Response to TOA Comments – 23–31 Dover Road, Rose Bay

We are writing on behalf of Dover Street (Rose Bay) Developments Pty Limited (**the proponent**) in respect of the State Significant Development application (**SSDA**) (SSD- 86017721) for an in-fill affordable housing development at 23–31 Dover Road, Rose Bay (**the project**).

This information is submitted in response to the Request for Additional Information (**RFI**) issued by the Department of Planning, Housing and Infrastructure (**DPHI**) via email on 11 March 2026.

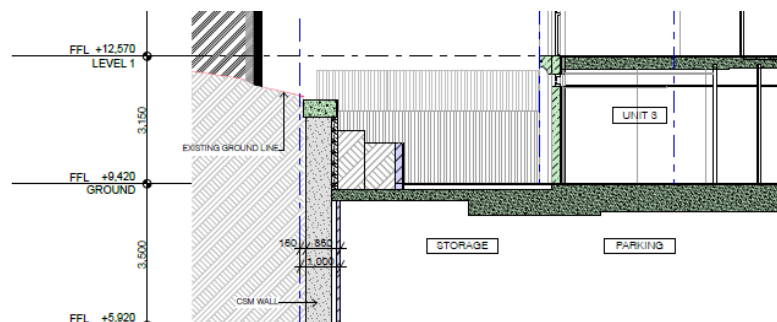
DPHI Query	Status
1. The Department has concerns over the size of the storage spaces provided on the basement levels especially on the eastern side of the basement. Due to the storage sizes the development does not have side setbacks/ deep soil along the eastern property boundary. The Department notes that the Applicant has advised	The storage space is not causing the size of the basement, the basement structure relates to the safest and most efficient way of constructing on that boundary, given the required retaining way and associated structural integrity. An amended design is proposed for the basement to help address the DPHI's comments. The footprint of basement level 1 and basement level 2 has been reduced by pulling back the eastern corner from 5,280m to 10,128m and 4,834m to 5,525m, as per the below:

that basement redesign is not a feasible option and will require additional excavation, however looking at the storage sizes recommended in the ADG, the storage areas can be resized to comply with the ADG requirements. Units 14 – 22 and 34 – 42 have approximately 26sqm of storage which can be reduced whilst still providing room for bicycle storage.

This results in a reduction from 1,823 m² to 1,792 m² internal building footprint area in the basements.

The reduction in the basement extent allows for an increase in deep soil zones compared to the SSDA October 2025 scheme of:

Provision	SSDA October 2025	RTS April 2026
Tree canopy: 15%	15.4% (409.6sqm)	28.4% (755.69sqm)
Deep soil zones with a minimum dimension of 3m (Tree Canopy Guide for Low- and Mid-Rise Housing): 7%	9.8% (261.5sqm)	11.4% (302.5sqm)
Deep soil zones with a minimum dimension of 6m (NSW ADG): 7%	2.7% deep soil (71.74sqm)	3.2% (86.9sqm)

In addition to the increased deep soil provision, the revised design enables further soil planting along the side boundary. This allows for the planting of 1,000mm medium-sized trees in place of the previously proposed small trees, resulting in a significant uplift in canopy coverage. The trees are proposed to be planed in planter boxes with a depth of 68m³ which is greater than the minimum 35m³ volume requirement for medium trees under Section 4P of the NSW Apartment Design Guide. This will supplement deep soil planting on the sites where opportunities for this are limited.

As illustrated in the table above, the revised design results in a significant increase in canopy coverage from 15.4% (409.6sqm) to 28.4% (755.69sqm). This is well above the minimum requirement of 15%.
